MEMORANDUM

To: Salt Lake City Historic Landmark Commission
From: Madison Blodgett, Principal Planner, madison.blodgett@slc.gov
Date: September 3, 2026
Re: PLNHLC2026-00368, Major Alteration at 378 N Quince St

Major Alteration

Review the revisions made to the Major Alteration request since the August 6th 2026, Historic Landmark Commission meeting, and make a decision on the request.

1 SOUTH ELEVATION
SCALE: 1/4" = 1'-0"

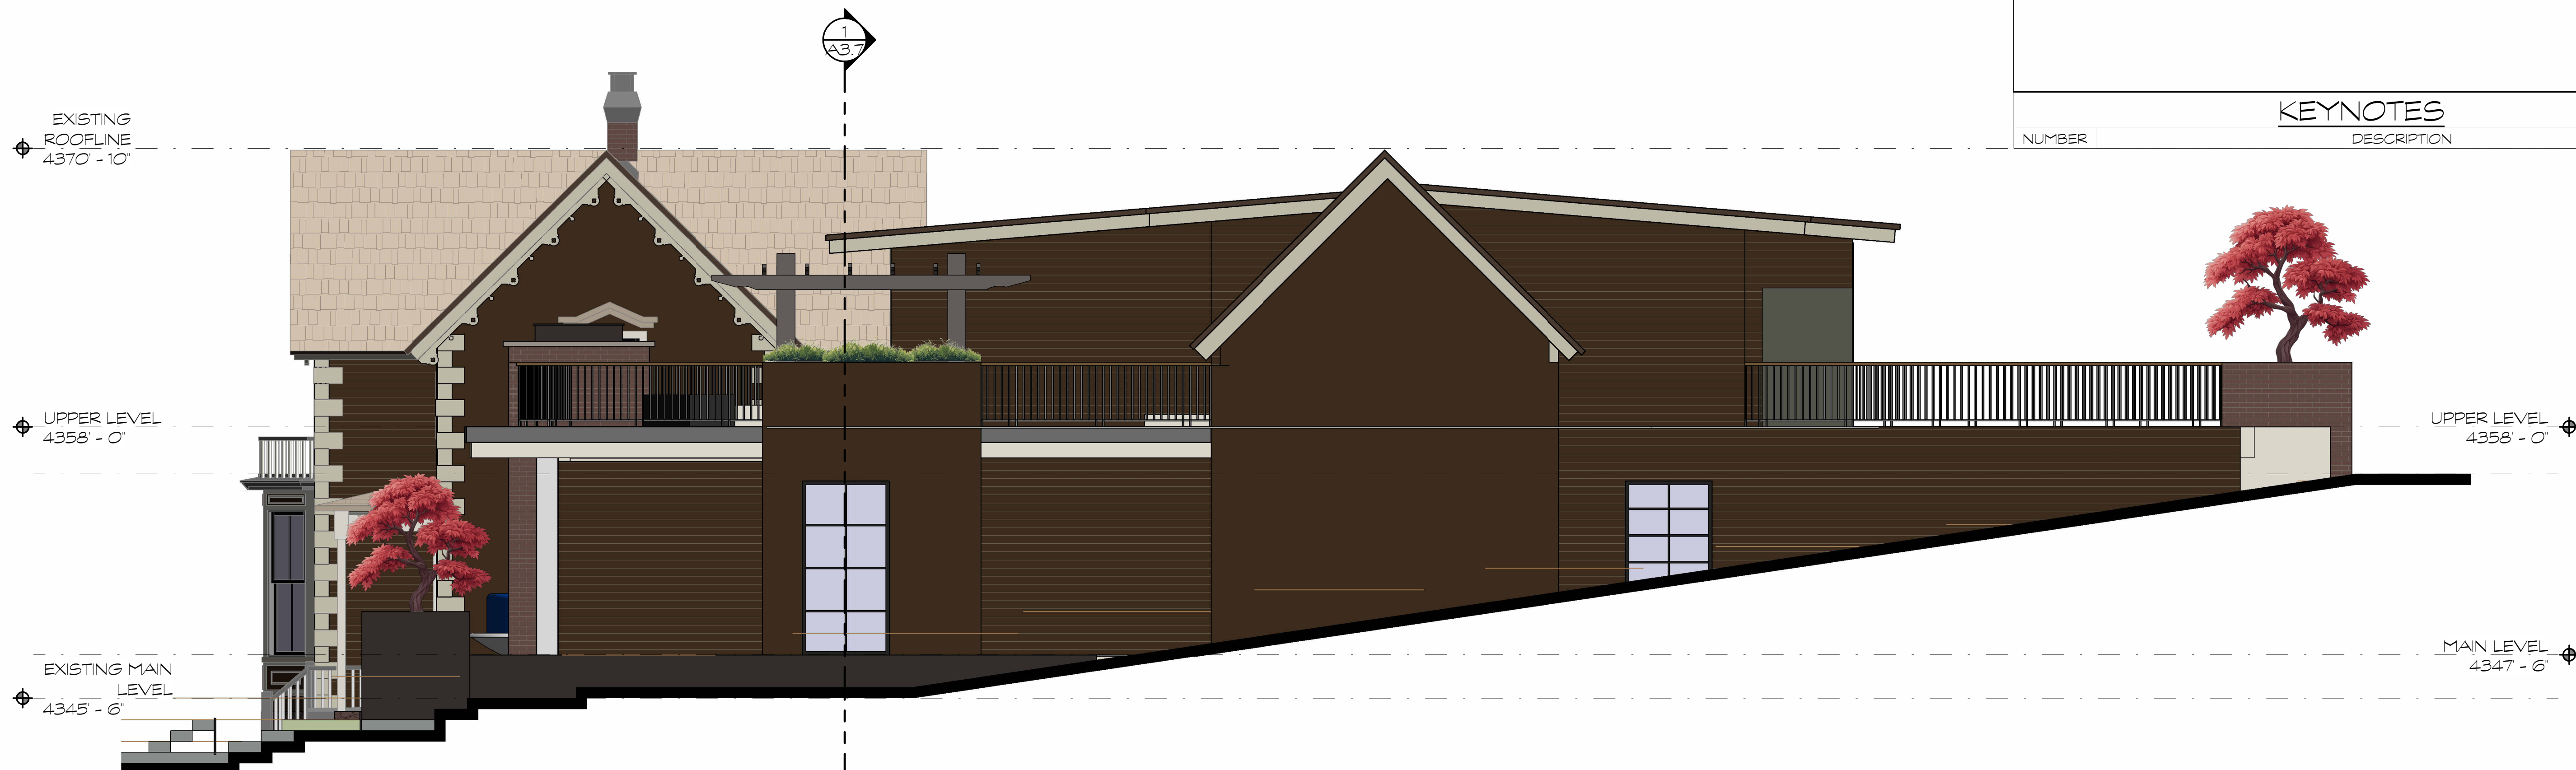
Compatibility of Scale, Color and Materials: Specifically, the scale of the brick planter on the public street facing elevation was found to be too visually prominent and not complementary to the existing house, which is primarily clad in wood siding. Concerns also included the proposed use of reclaimed barnwood and the extreme curvature of the front balcony.

- The brick planter on the street facing elevation has been redesigned as a functional chimney, reducing the scale and visual mass. The proposed chimney is designed to reflect the size and height of the brick chimney on the existing house.

2. Two-Story Planter Revised as Chimney

The previously proposed two-story planter has been redesigned as a **functional chimney**.

The overall scale of the element has been reduced, along with a substantial reduction in the amount of brick. This revision replaces the previously proposed planter with a recognizable

A3.2
1/4" ELEVATIONS

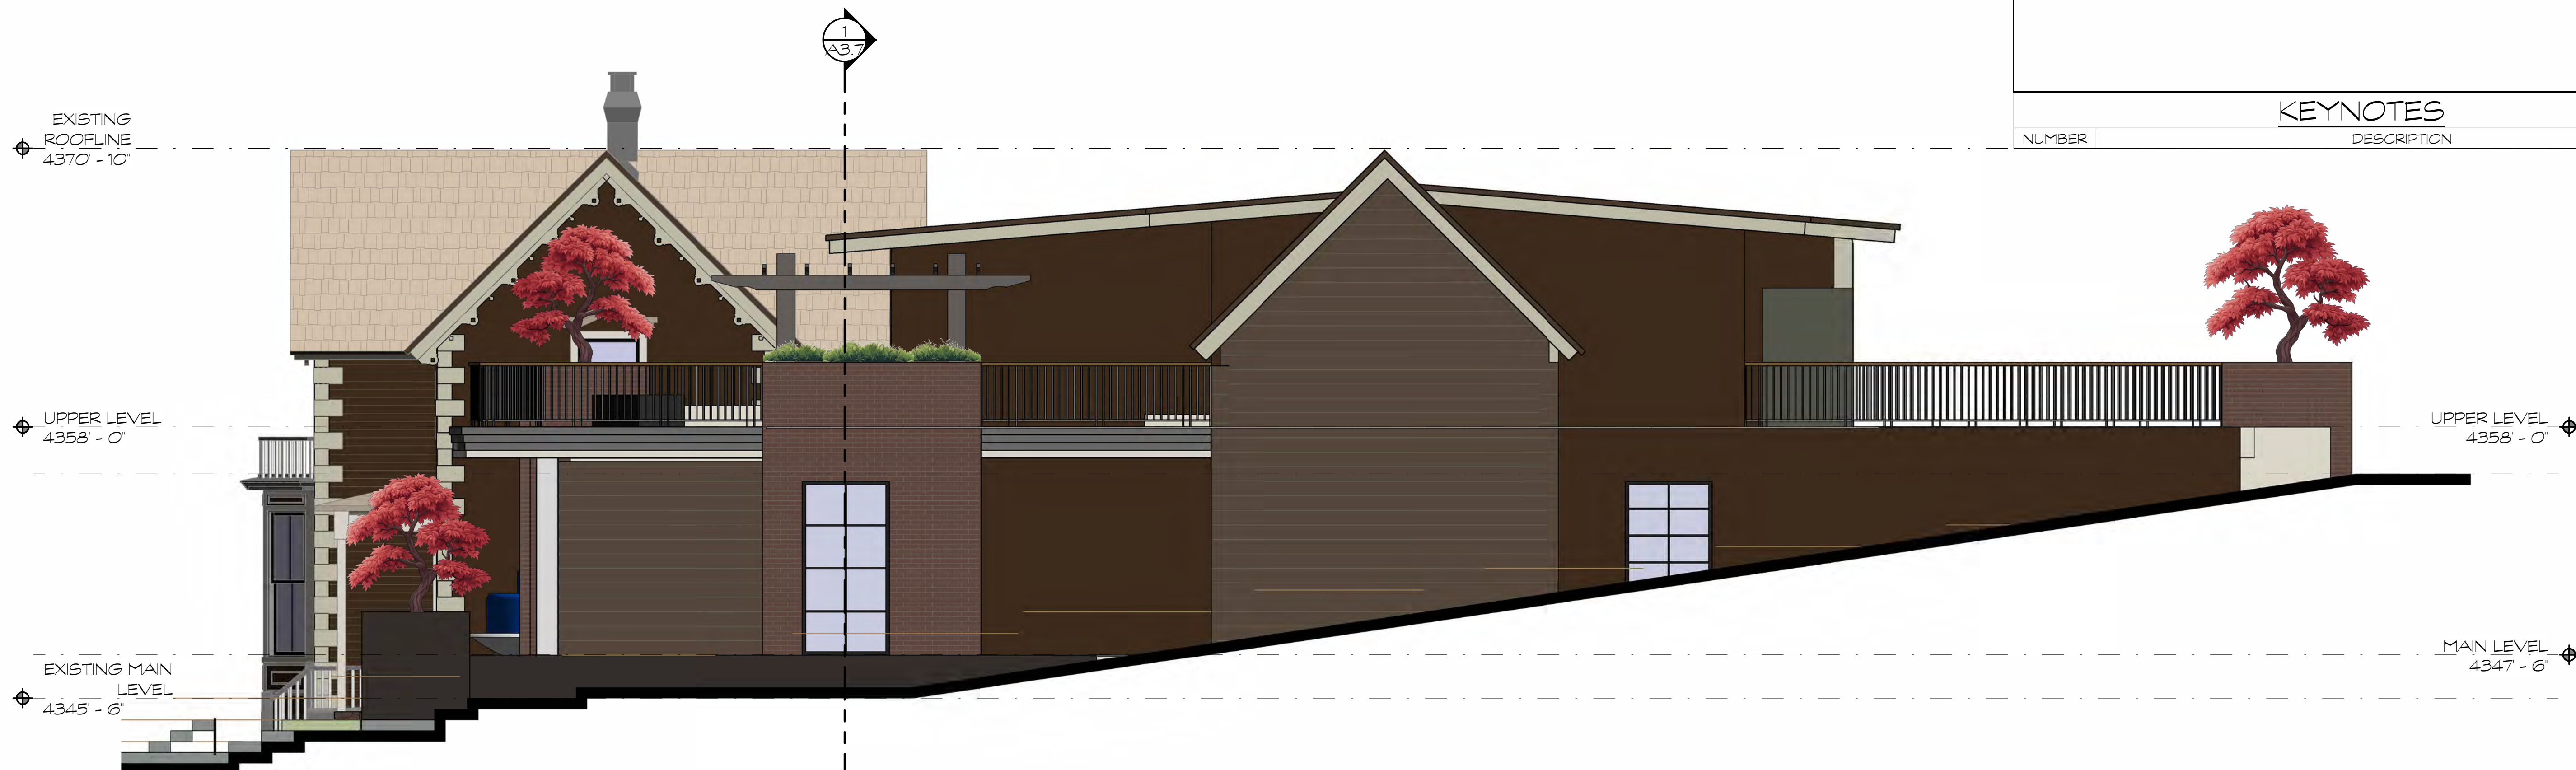
The addition has a proposed height of 25 feet. Although the proposed height exceeds the maximum height of 23 feet in the SR-1A zoning district, the proposed height matches the height of the existing structure. Per [21A.06.050.C.6.f](#), the Historic Landmark Commission has the authority to approve certain modifications to zoning standards if it furthers the

The front façade windows of the addition are designed as a modern interpretation of the original two over two double-hung bay windows and are recessed a minimum of 3". The entry is recessed to reflect the pattern of the historic home, including a covered porch element supported by a single column. The windows proposed for the rear and sides of the addition follow the two over two style and are not visible from the street. On the existing house, sliding glass doors will be installed on the rear of the first story to provide access to an outdoor dining area.
